MEINERS OAKS DAM, NO. 768
1/29/69 JJH

INSPECTION OF DAM AND RESERVOIR IN APPROVED STATUS

Name of dam Meiners Oaks Dam No. 768
Type of dam Earth Type of Spillway Concrete culvert
Water is 3 feet below spillway crest and _____ feet _____ dam crest.
(above, below) (above, below)
Contacts made Mr. Jackson of Meiners Oaks County Water District
Detail in question Periodic inspection
Action taken See "Remarks"

Review of "As Constructed" Drawing February 18, 1955

General view of reservoir from the left side; the area outlined by the dashed inked line is proposed for removal to increase storage capacity.

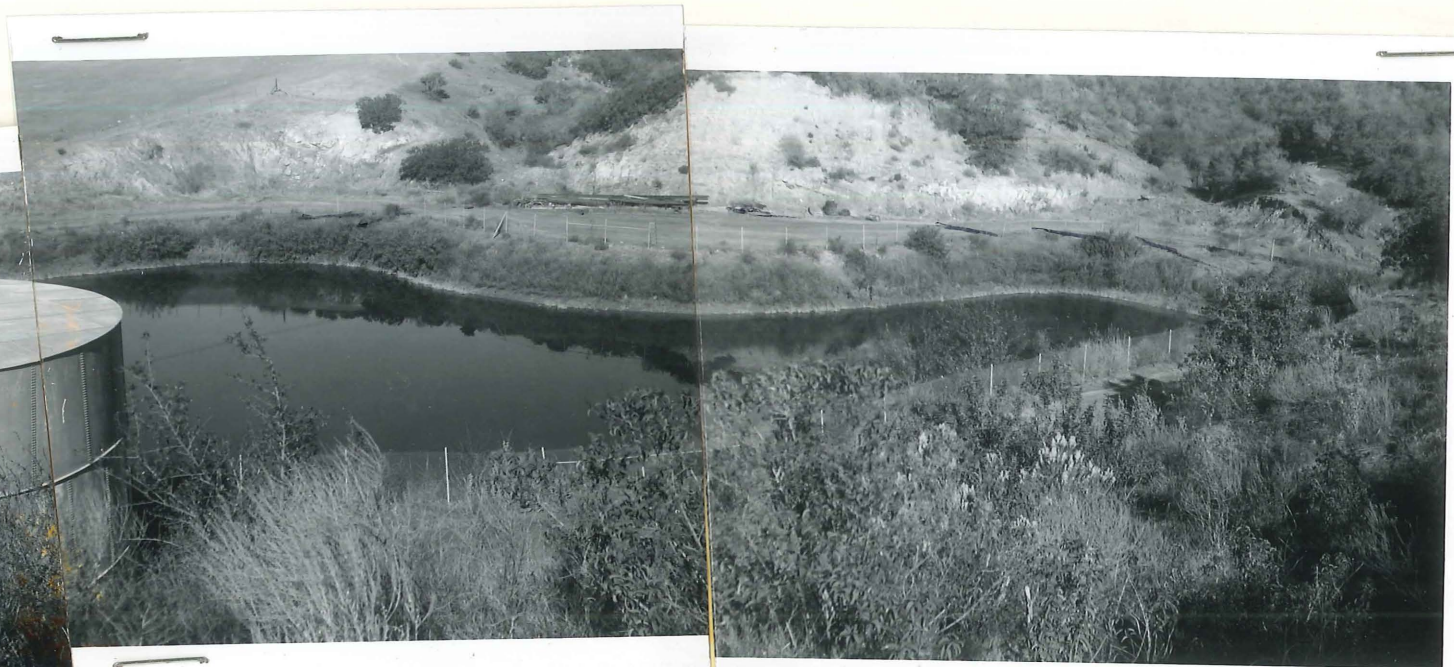
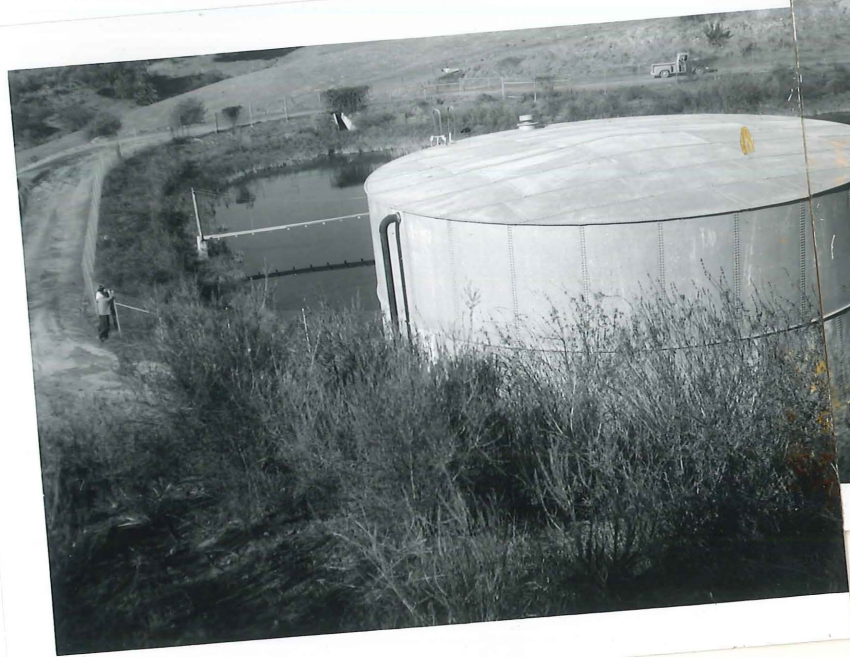
Due to development growth, the Water District is considering increasing the storage capacity of Meiners Oaks Reservoir.

They intend to excavate a projecting area at the upstream right side of the reservoir. Removal of the material could increase the capacity from 6,000,000 to 7,000,000 gallons, according to Mr. Jackson. Removal of this material would have no effect on the dam. The excavated material would be hauled away. The writer asked that we be given the new capacity figure if the work is done. They will drain the reservoir in the near future for cleaning.

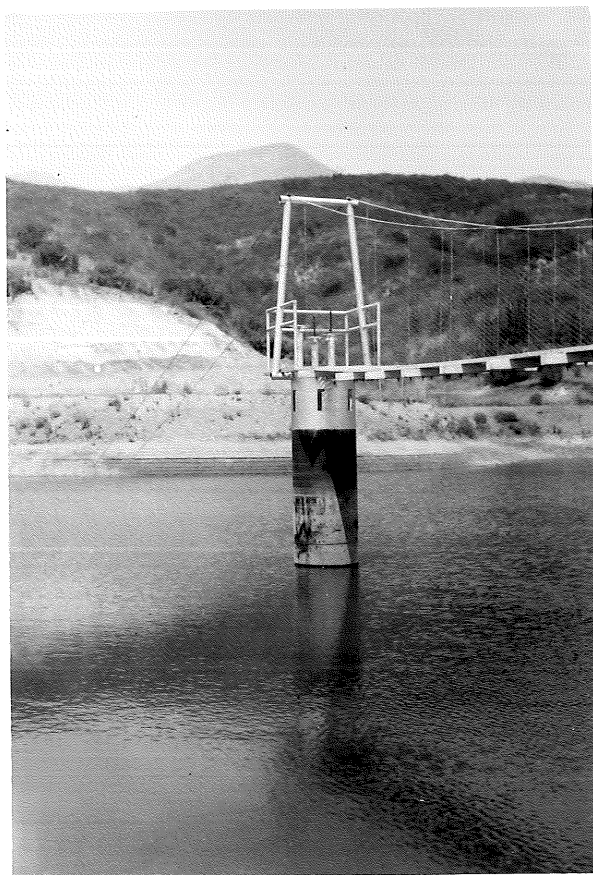
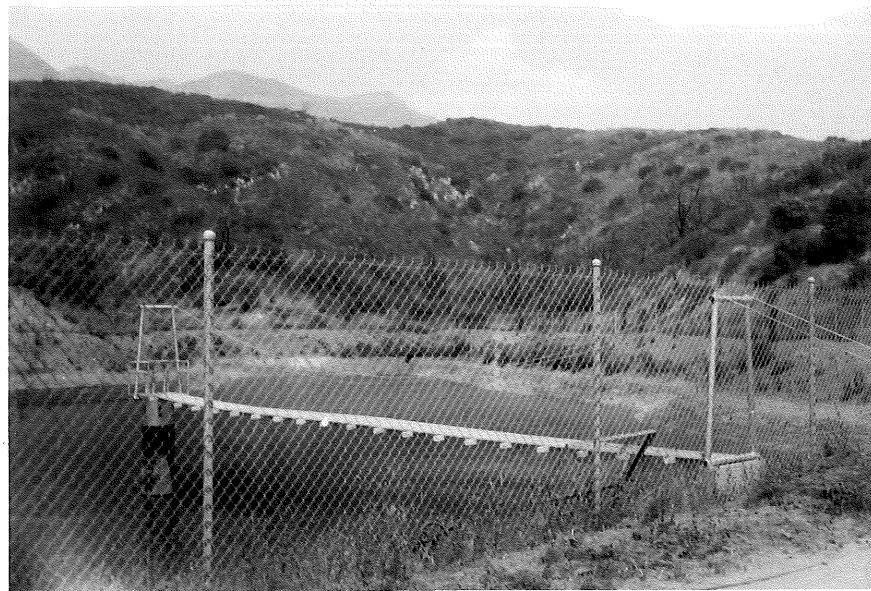
An outlet tower has recently been constructed at the subject dam without State approval, see accompanying pictures dated July 14, 1954. Mr. Dron in a letter to Mr. Spielman dated March 10, 1954, mentioned their intent to build such a structure and submitted duplicate prints at that time along with as constructed prints of the completed dam. This letter was acknowledged by Mr. Spielman by his letter to Mr. Dron dated March 17, 1954, giving pertinent information regarding procedure for approval along with returning one set of as constructed prints of the dam marked up to show requested changes and additions. Nothing more was said of building the outlet tower until the writer made the subject inspection. Mr. Briggs was informed that since the dam had never been approved the cost of the tower would now have to be included in the original cost of the dam upon which the fee is based. They have an itemized statement prepared by Mr. Young showing the cost of the reservoir before the tower was built along with a separate cost of the tower. When Mr. Dron's engineering fees for services rendered on the construction of the outlet tower are received they will have all necessary data for the completed cost statement. The writer explained the procedure in calculating the fee due since the final cost exceeded the estimated by more than 10 per cent. However, the State must now consider approval of the outlet tower from a structural standpoint. In this regard there were some changes made to the original plans according to Mr. Briggs which mainly included placing a reinforced concrete slab base around the tower to increase stability.

1. Remove the one foot of flashboard (has never been approved for).
2. Remove 2 $\frac{1}{2}$ ft. of road fill at culvert exit. (Placed with 12 inch culvert by County to build-up road for hauling operations.)
3. Change location of gate grill to upstream side.

1. Submit in duplicate as constructed prints of the outlet tower for check by the State of structural adequacy; if found satisfactory, tracing will be required later.
2. Submit as constructed tracings of dam.
3. Submit completed cost statement to include cost of outlet tower.
